Department of Nuclear Engineering

Docket No. 50-059

SUBJECT: RESPONSE TO "TEXAS A&M UNIVERSITY AEROJET GENERAL NUCLEONICS
MODEL 201-MODIFIED REACTOR CONFIRMATORY ACTION LETTER REGARDING
SHUTDOWN RELATED TO REACTOR SAFETY SYSTEM."

Introduction

Figure 1.1: Channel 2 Functional Block Diagram

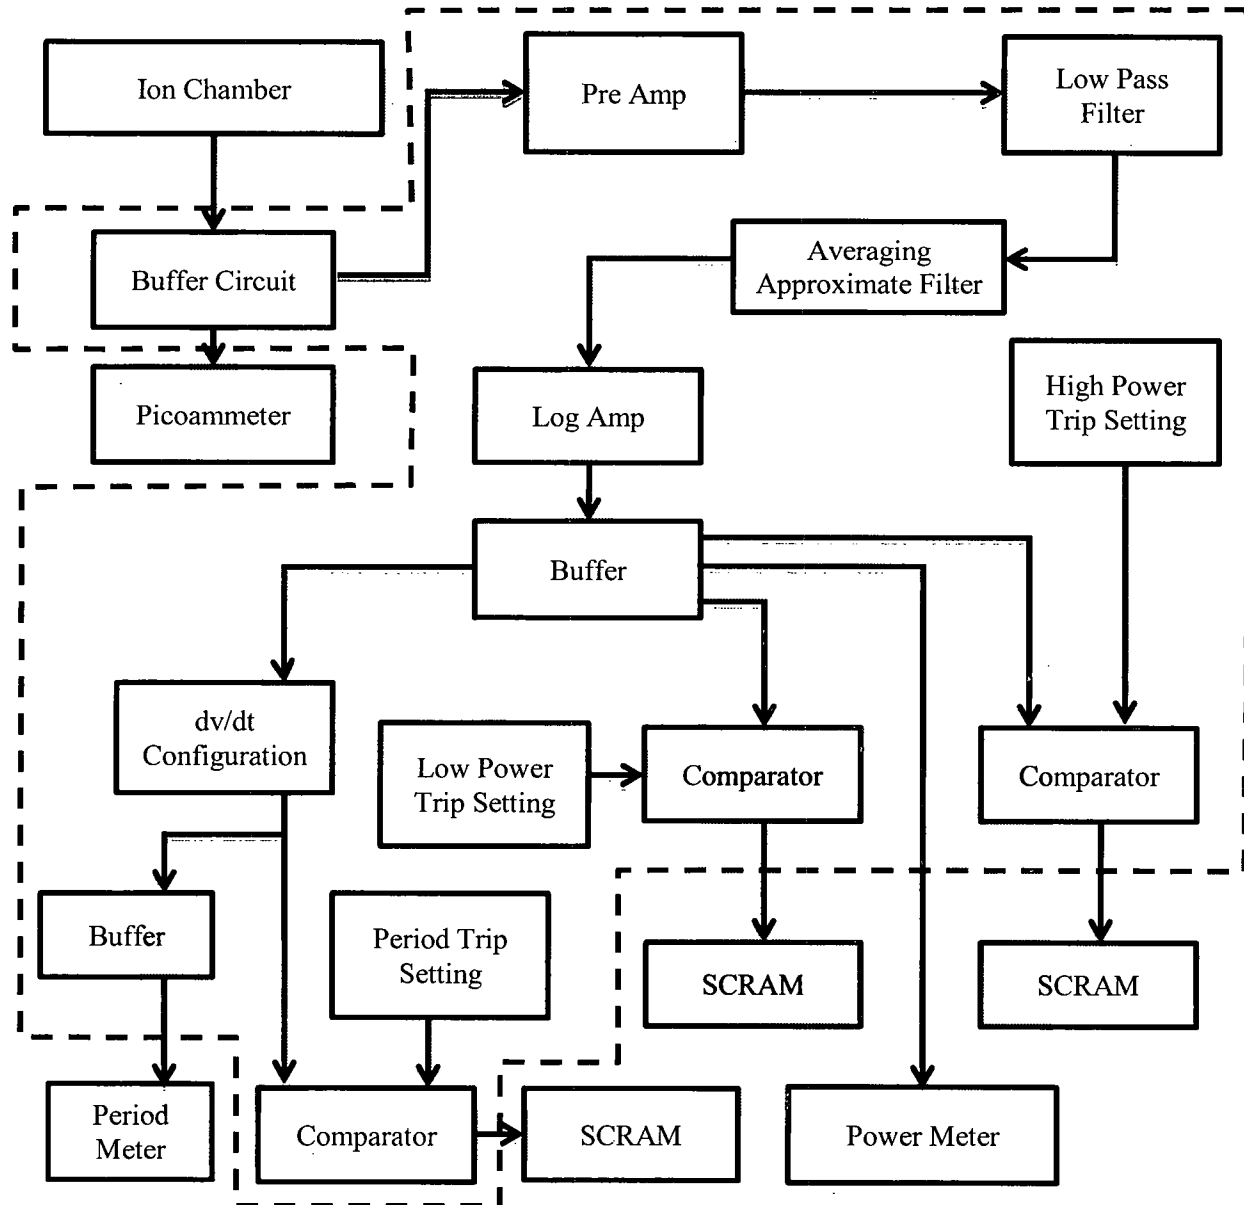
The proposed analog circuit is outlined in the functional block diagram presented in Figure 1.1. The portion of the figure enclosed by the dashed line indicates the proposed analog portions of the log channel including appropriate inputs to the reactor safety system. The portions outside the dashed box represent existing equipment. The log channel ion chamber output signal is received by the buffer circuit. This buffer circuit will utilize an op-amp buffer to replicate the input signal and provide independent outputs to the analog and digital portions of the log channel. The buffer circuit will also act as a current follower to ensure the digital and analog portions of the system are isolated from one another. The analog output is sent to the pre-amp where the incoming signal is amplified before it is passed to the low pass filter. The low pass filter removes high frequency noise, including common 60 Hz interference. This filtered signal is passed to the averaging approximate filter to create a moving average approximation. The following equation will be used to implement this filter:

The output of the derivative is 180° out of phase; therefore, an analog inverter has been included in the configuration. The output signal of the log amplifier will also be sent to a high and low power comparator to determine if a safety shutdown should occur given the input. If this value meets or exceeds a safety set point, a scram signal is generated and sent to the scram circuit and alarm panel, initiating a protective action resulting in power interruption to the electro-magnets and the corresponding alarm light illumination. The log amplifier also drives indication of reactor power while the derivative function provides input to reactor period indication.

The new hybrid log channel will be composed of a digital interface used solely as an operator aid and will provide no contribution to the reactor protection system. The other portion of the log channel will be an analog circuit providing input to the reactor protection system in accordance with Appendix A to License No. R-23, section 3.2.

Figure 1.2: Channel 3 Functional Block Diagram

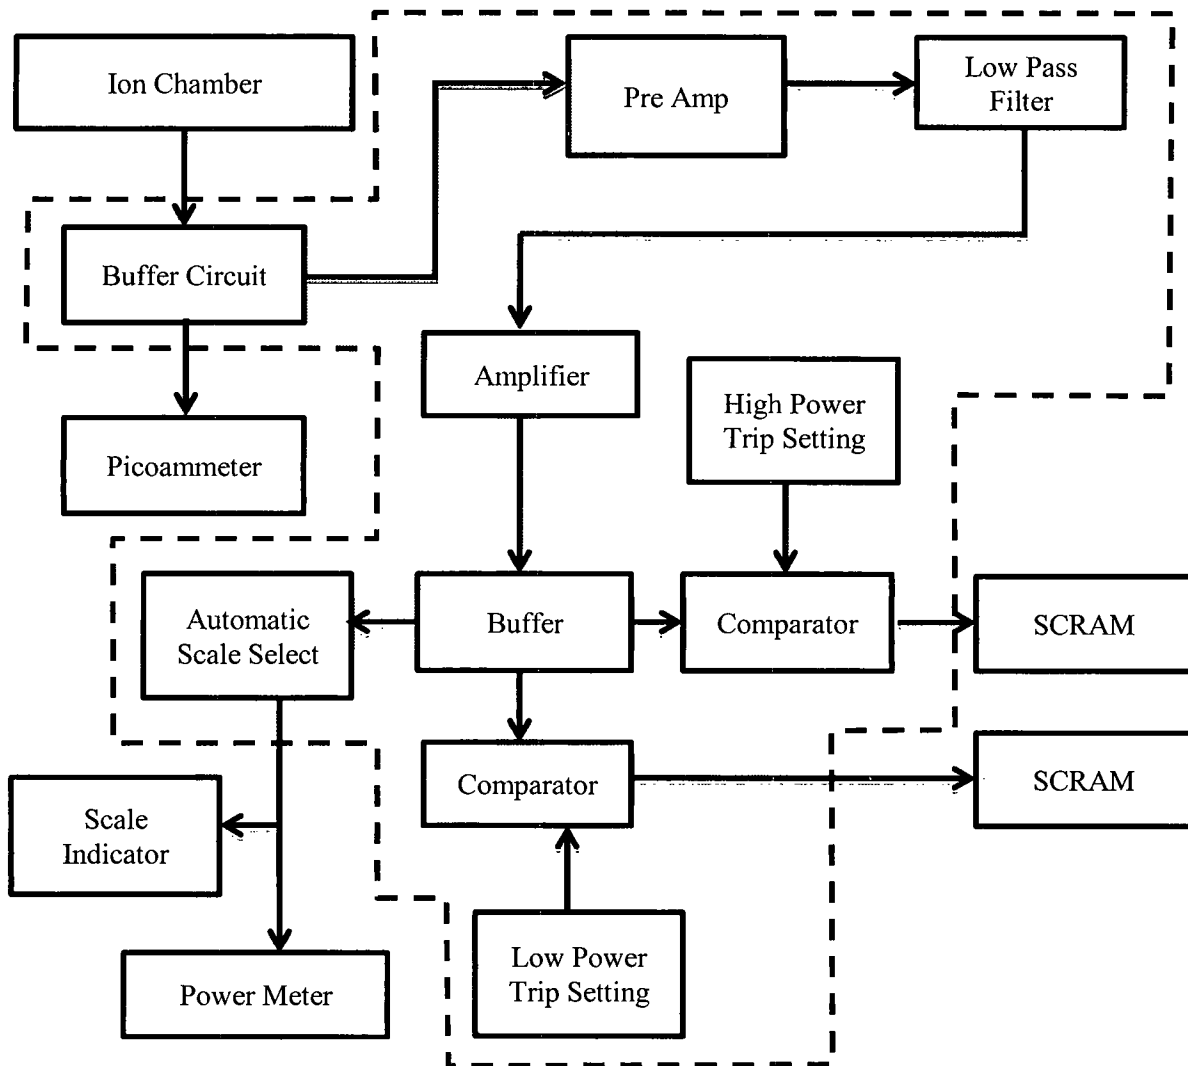
The proposed analog circuit is outlined in the functional block diagram presented in Figure 1.2. The portion of the figure enclosed by the dashed box indicates the proposed analog portions of the linear channel including appropriate inputs to the reactor safety system. The portions outside the dashed box represent existing equipment. The linear channel ion chamber output signal is received by the buffer circuit. This buffer circuit will utilize an op-amp buffer to replicate the input signal and provide independent outputs to the analog and digital portions of the linear channel. The buffer circuit will also act as a current follower to ensure the digital and analog portions of the system are isolated from one another. The analog output is sent to the pre-amp where the incoming signal is amplified before it is passed to the low pass filter. The low pass filter removes high frequency noise, including common 60 Hz interference. The filtered signal is amplified to increase the gain for further processing. The output signal of the amplifier is sent to a high and low power comparator to determine if a safety shutdown should occur given the input. If this value meets or exceeds a safety set point, a scram signal is generated and sent to the scram circuit and alarm panel, initiating a protective action resulting in power interruption to the electro-magnets and the corresponding alarm light illumination. The amplified signal is also passed to

the linear power meter and a scale indicator which provide visual indication of power level and decade of power.

The new hybrid linear channel will be composed of a digital interface used solely as an operator aid and provides no contribution to the reactor protection system. The other portion of the linear channel will be an analog circuit providing input to the reactor protection system in accordance with Appendix A to License No. R-23, section 3.2.

Figure 7.2.1-1: AGN Logic Diagram

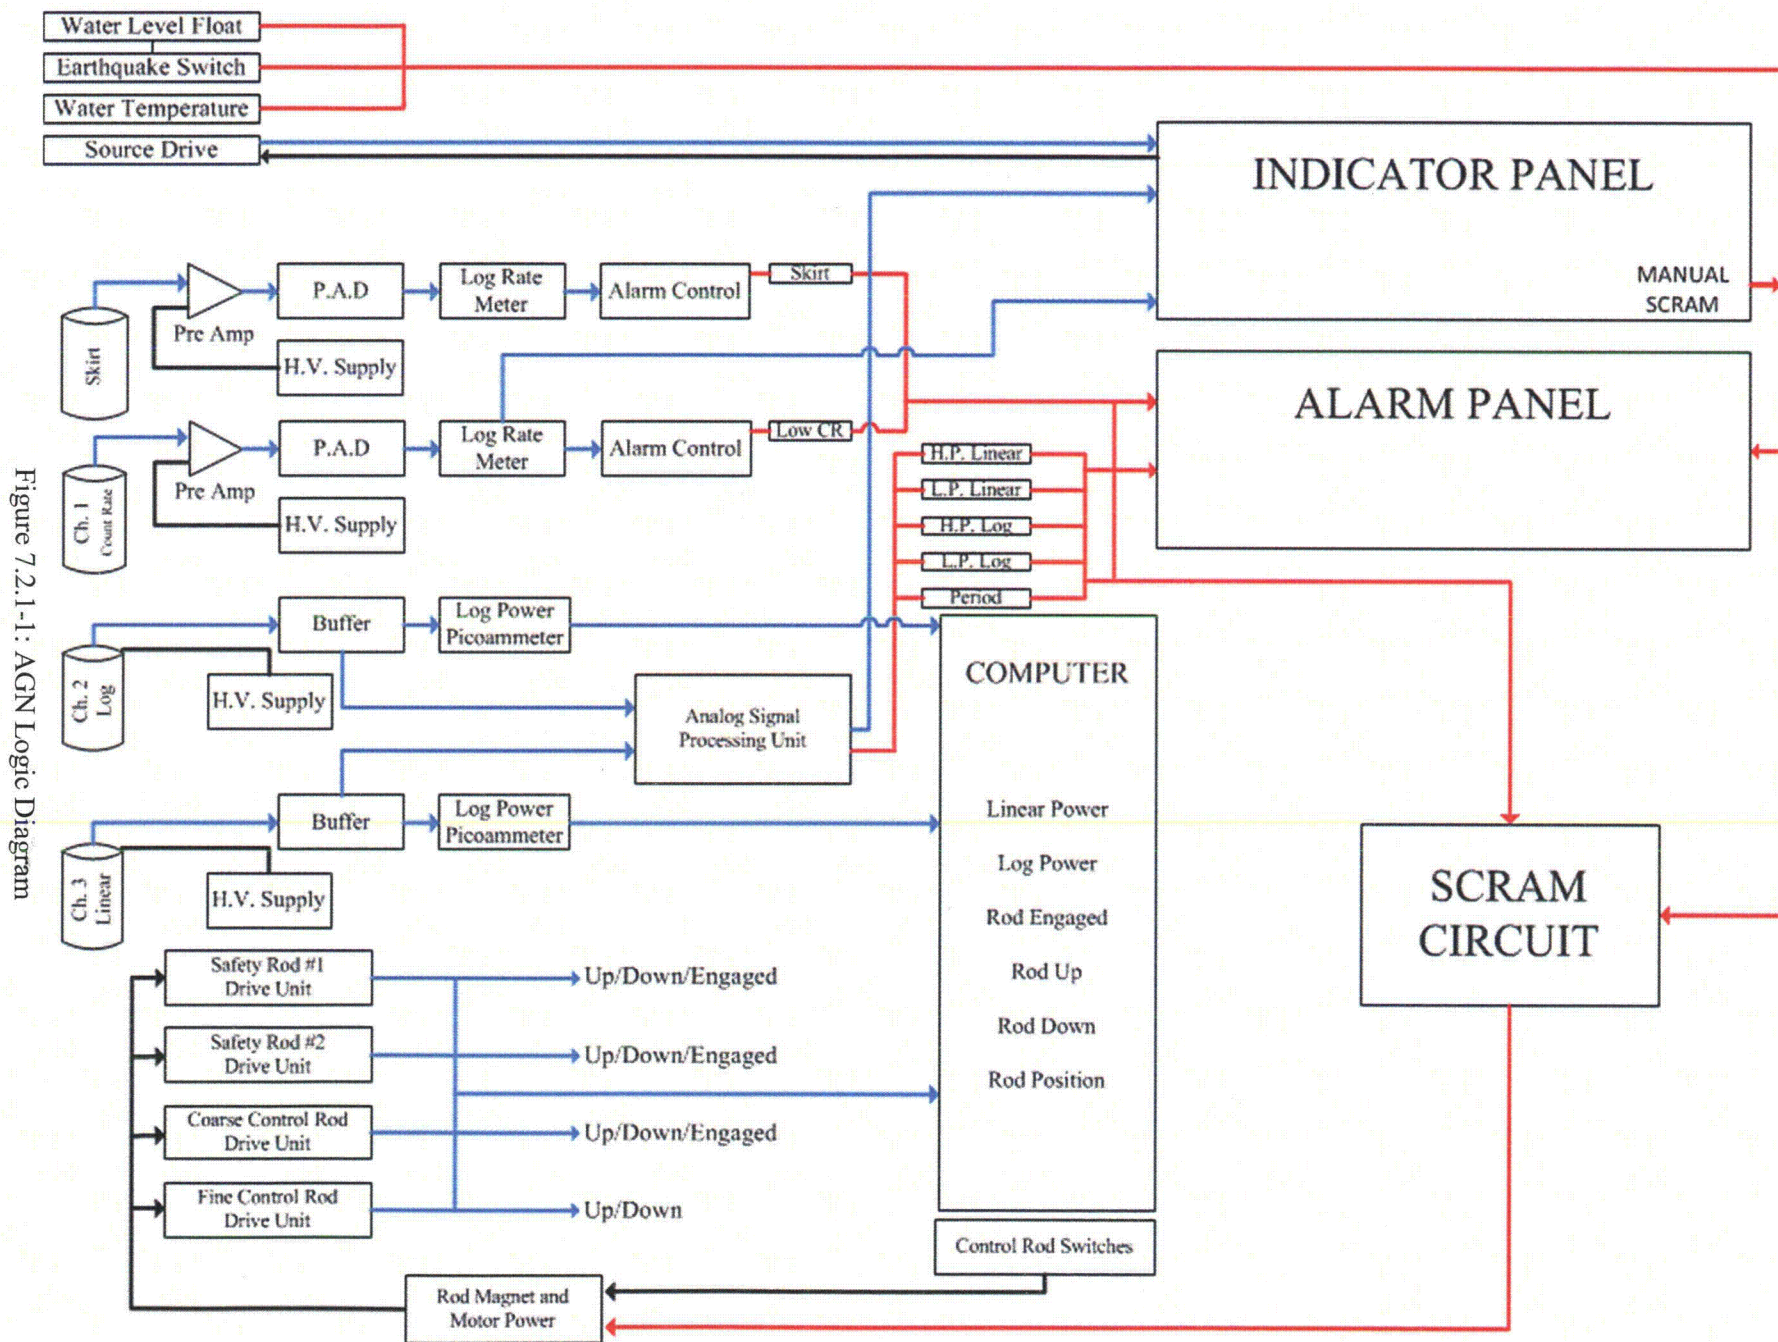
The resulting I&C system will include an analog and digital system operating in parallel. The digital portion of the system will provide an operator aid while controlling the reactor with no safety system input. The analog portion of the system will be used to provide indication of reactor power for the log and linear channels as well as perform the period calculation and indication while providing an input into the reactor protection system along with all other previous inputs to the safety system. This will restore the reactor control console to a completely analog reactor safety system. An updated logic diagram is presented in Figure 7.2.1-1.
